# Statement of Environmental Effects

Application under Section 96(1A) to Modify  
Development Consent SSD 5093  
North Ryde Station Precinct M2 Site -  
Lachlan's Line

Prepared for UrbanGrowth

19 May 2016

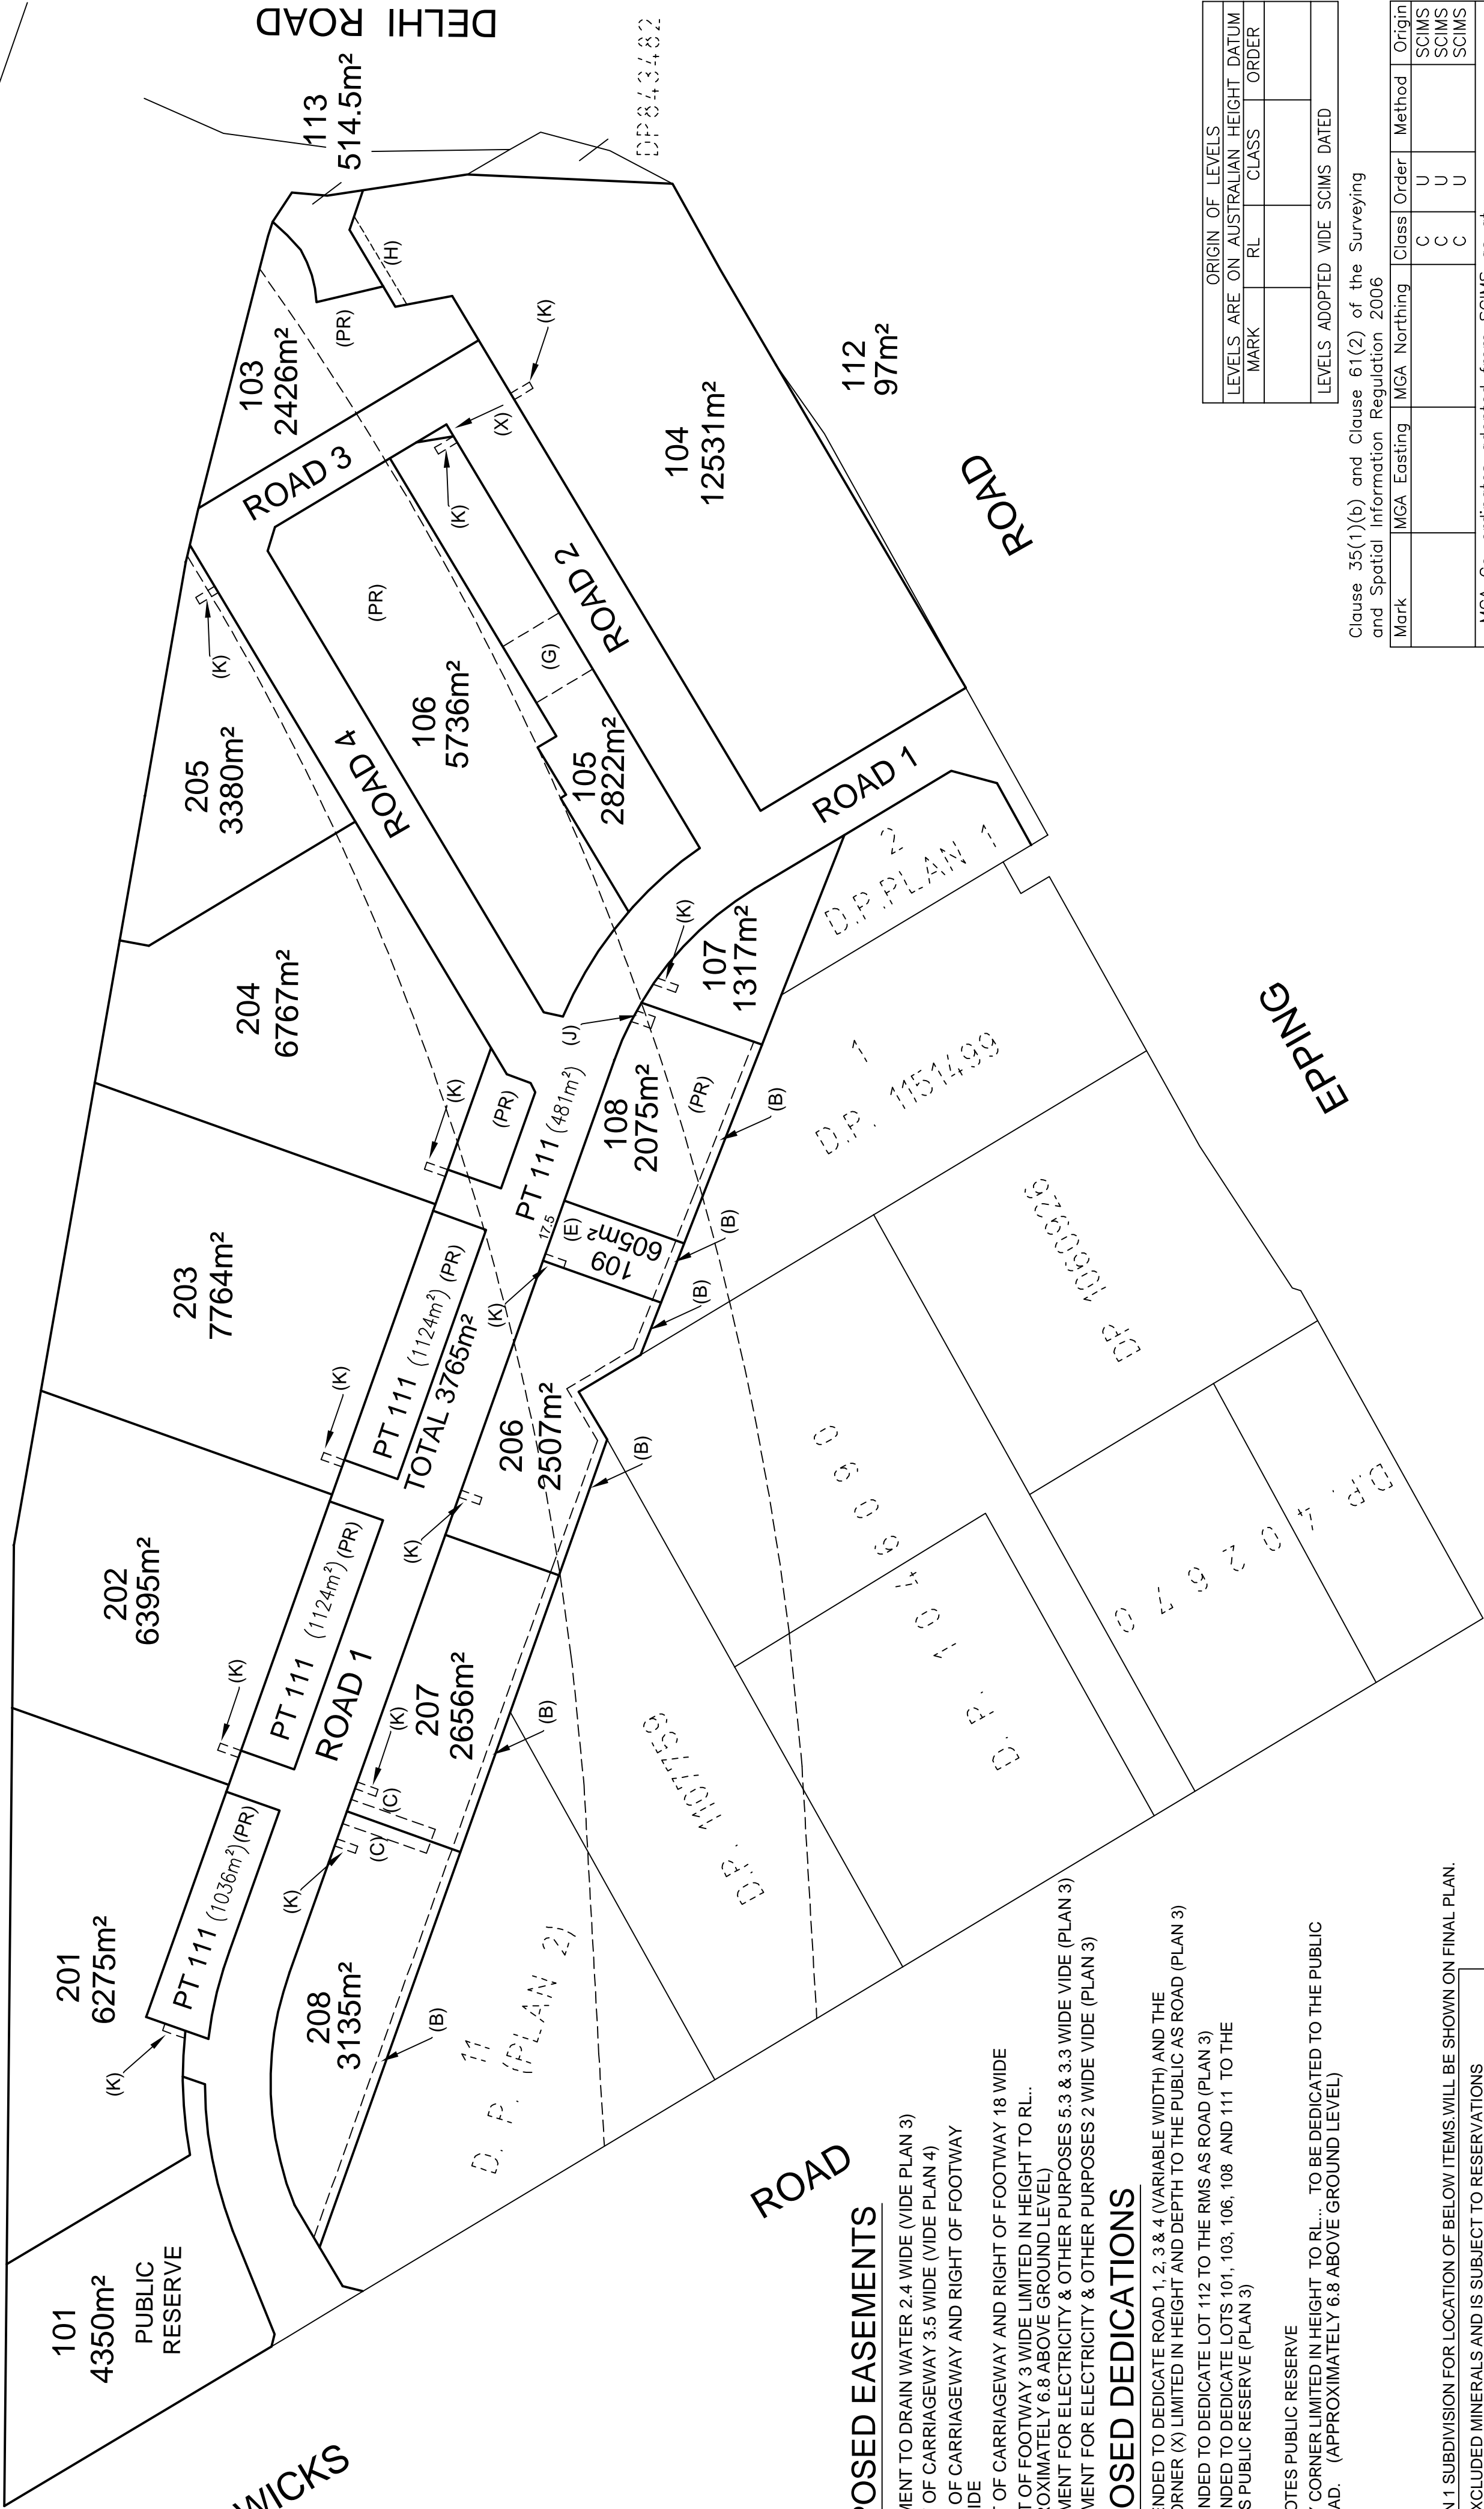
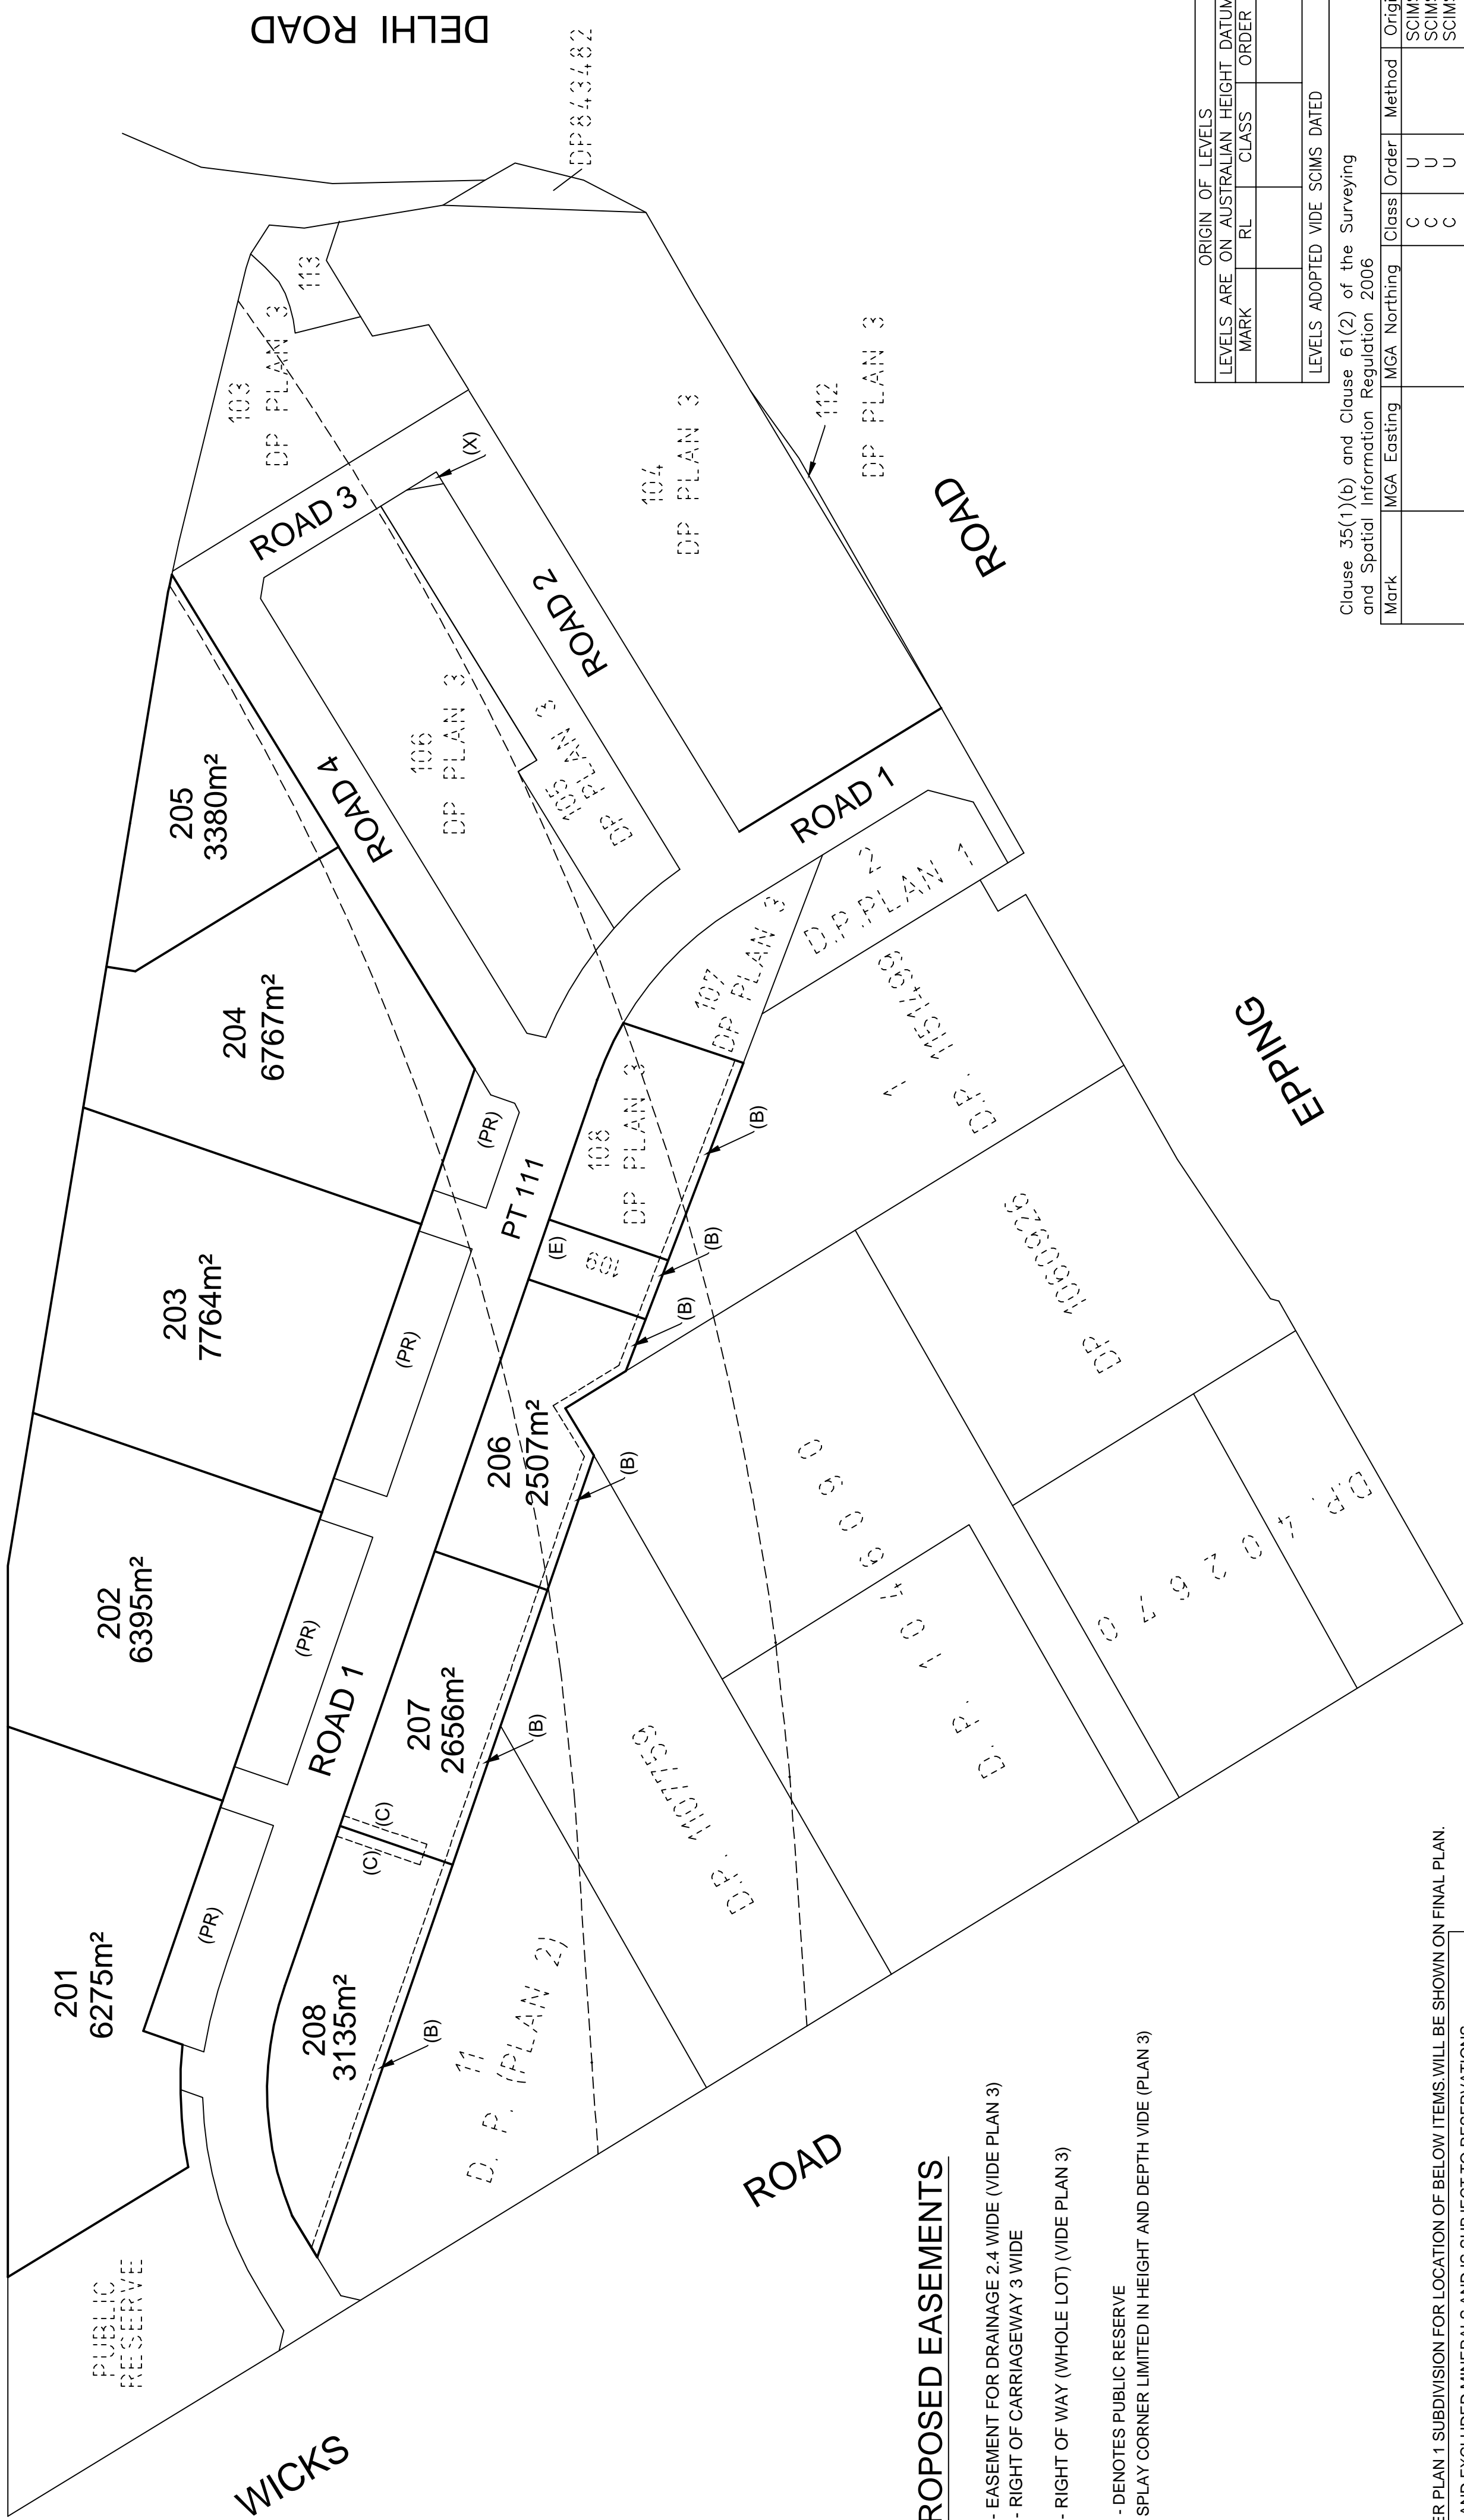
The land on which the pedestrian and cycleway bridge is located will be dedicated to the Roads and Maritime Services (**RMS**) when complete. As such, it is appropriate to further subdivide Lot 103 to exclude that land which will be dedicated to RMS for the bridge abutment on this part of the site from the land to be dedicated to Council as park. This arrangement is consistent with the draft Planning Agreement being negotiated between UrbanGrowth NSW and Ryde City Council.

<i>Draft Subdivision Plans by Scott Deveridge</i>			
<b><i>B1505-B1612 - OVERALL</i></b>	<b><i>K</i></b>	<b><i>Overall plan of subdivision Plans 1-4</i></b>	<b><i>18.6.15</i></b>
<b><i>B1505-B1612-PLAN3-K</i></b>	<b><i>K</i></b>	<b><i>Plan of Subdivision of Lot 10 in DP (Plan 2)</i></b>	<b><i>18.6.16</i></b>
<b><i>B1505-B1612-PLAN4-C</i></b>	<b><i>C</i></b>	<b><i>Plan of subdivision of Lots 102 and 110 in DP (Plan 3)</i></b>	<b><i>18.6.16</i></b>
